UTAH OIL AND GAS CONSERVATION COMMISSION

RE: Application for Permit to Drill -
Fotes 13-91, SW 1/4 of SW 1/4 of Sec. 13, T14S, R09E
S.L.B. & M., Carbon County, Utah

**ON-SITE PREDRILL EVALUATION AND REVIEW
FOR
APPLICATION FOR PERMIT TO DRILL (APD)**

OGM Review and Approval of Application for Permit to Drill (APD)

SW1/4 SEC. 13, T 14 S, R 9 E, S.L.B. & M.		
Empire Engineering		
1665 E. Sagewood Rd. Price, Utah 84501		
RIVER GAS CORPORATION		
WELL # FOTES et al 13-91		
Drawn By: THK	Approved By: EEH	Drawing No.
Date: 4-15-95	Scale: 1" = 40'	EEOG-95-02
		Sheet: 2 of 2

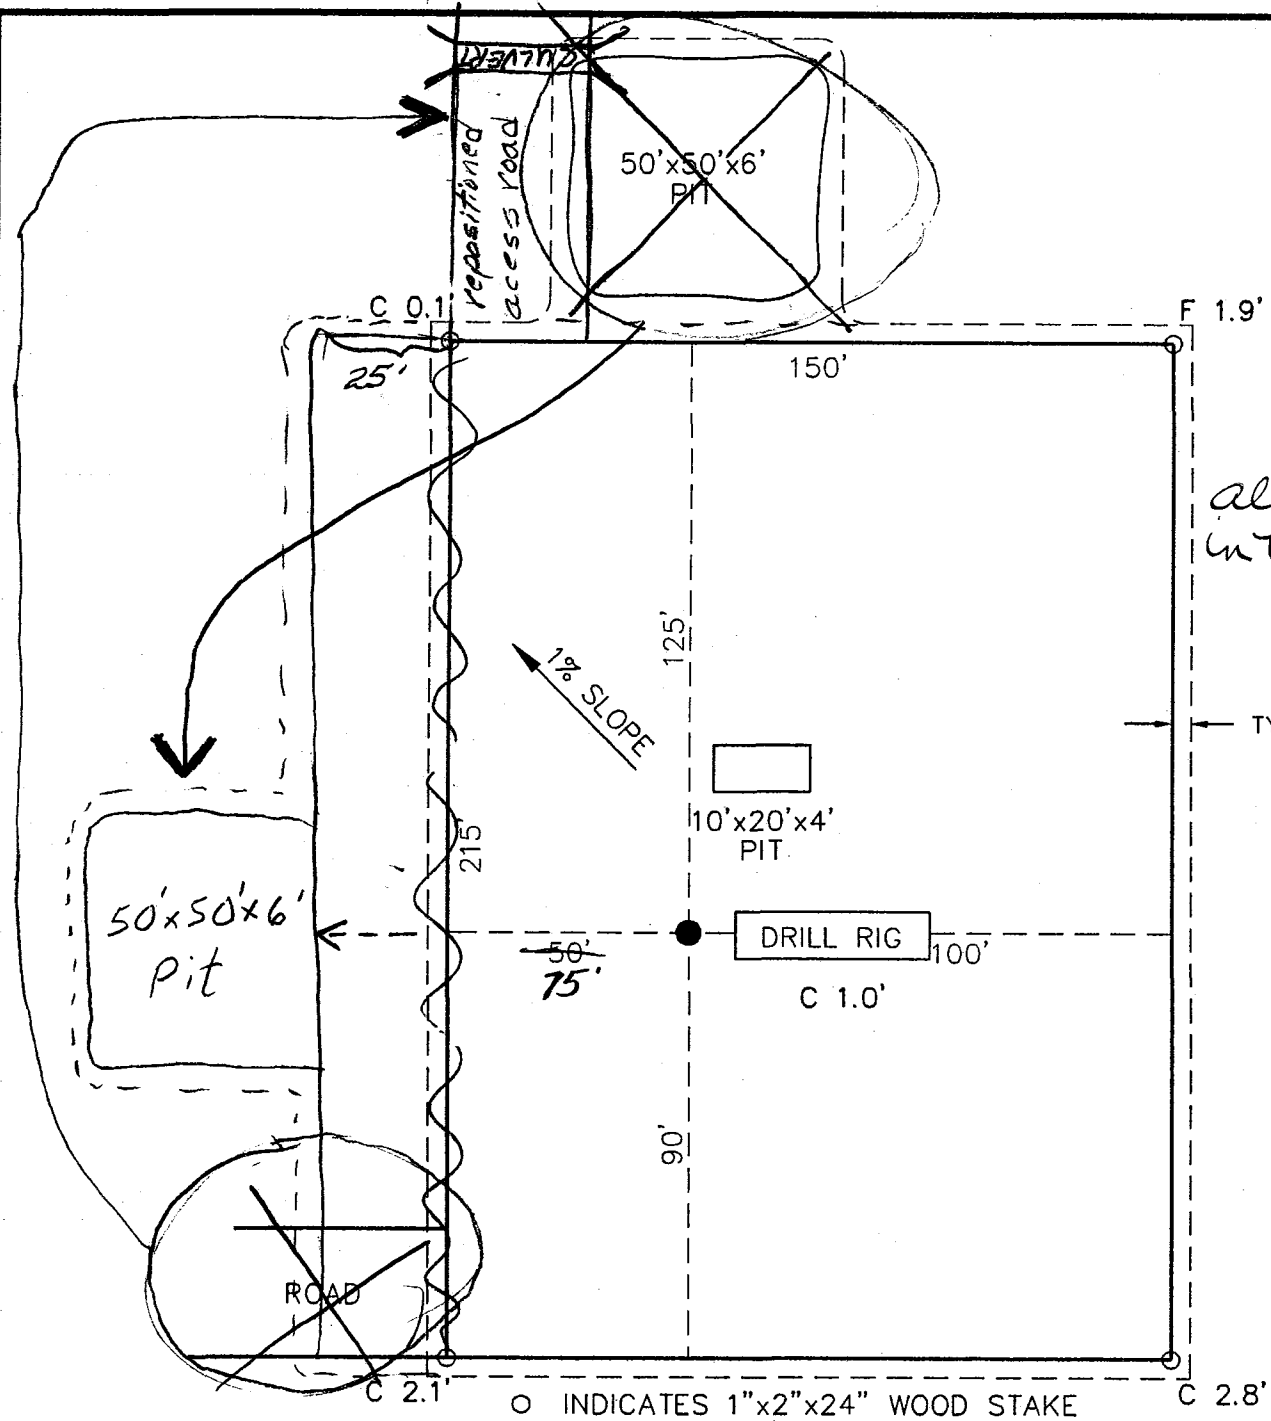
Changes made to site layout plat:

1. reserve pit is moved to the west edge of the pad.
2. access road is moved to the northwest corner of the pad.
3. the west side of the pad is moved 25' farther west.
4. Recommend that the 2500' pipeline access road receive three 18" culverts and one 24" culvert in certain minor arroyos and a concrete-floored low water crossing in Pinnacle Wash.

1. If organized lenses of sand or gravel are encountered while digging the pit the operator will seek D.O.G.M. guidance regarding the need for a more competent liner.
2. A culvert will be laid in the bar ditch of the existing road to accomodate the access road.
3. Site infrastructure as per modified drilling location plat provided by Steve Prince at onsite meeting.

River Gas Corp. Fotes et al 13-91
location

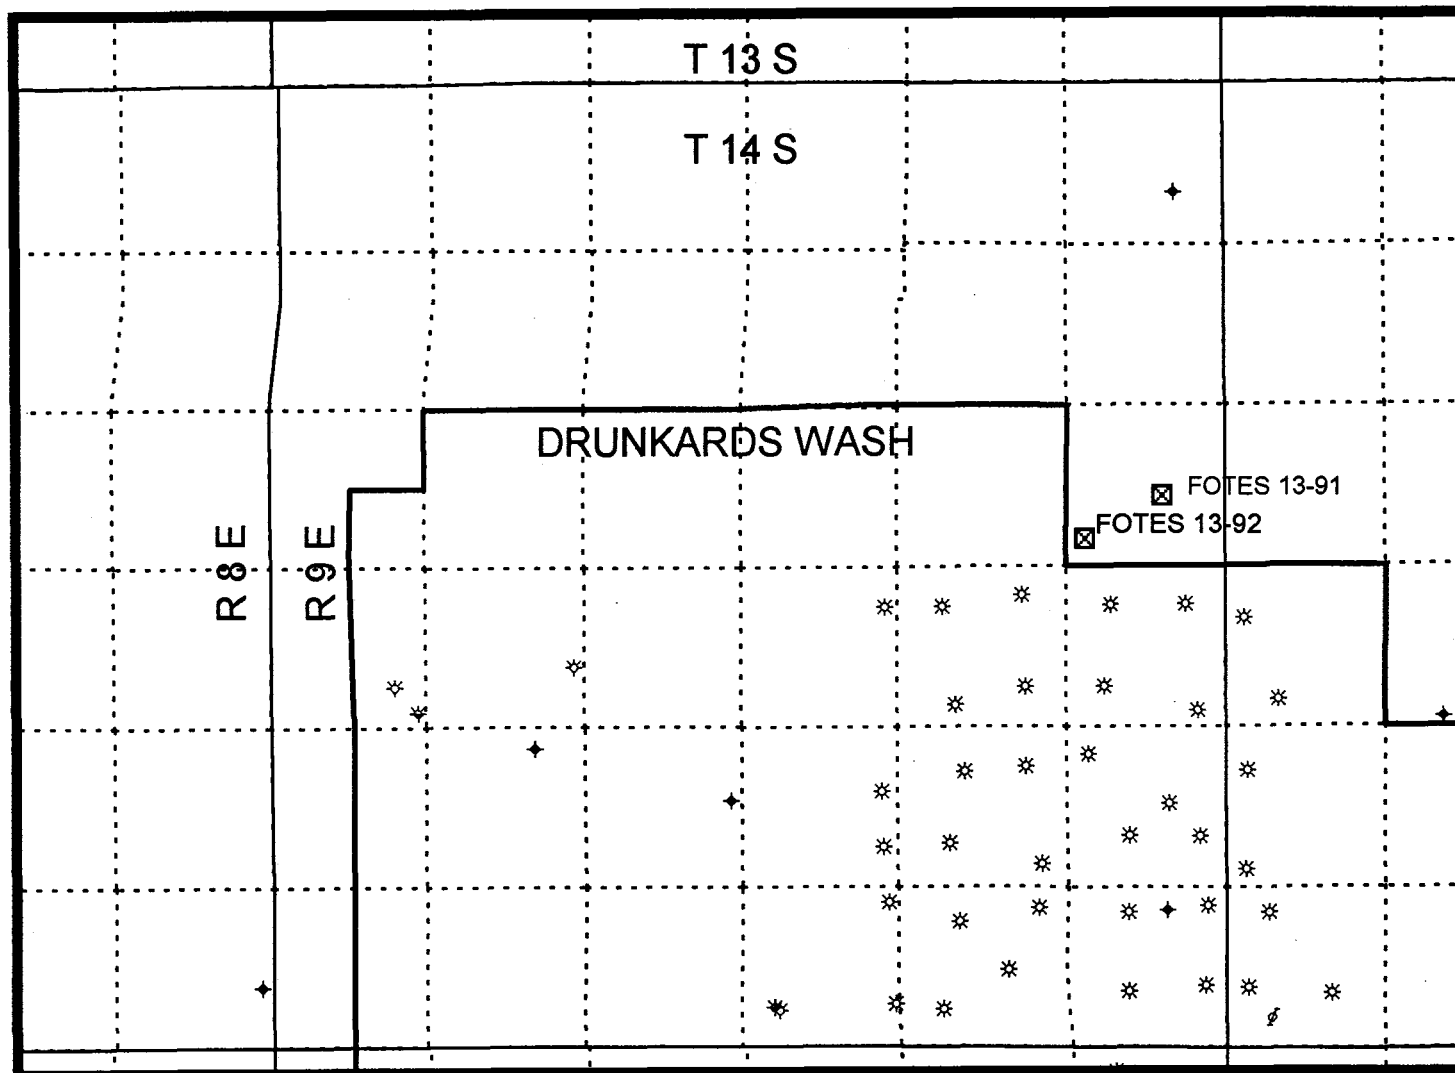
View to North - stake 1/4" to right of
gray vehicle
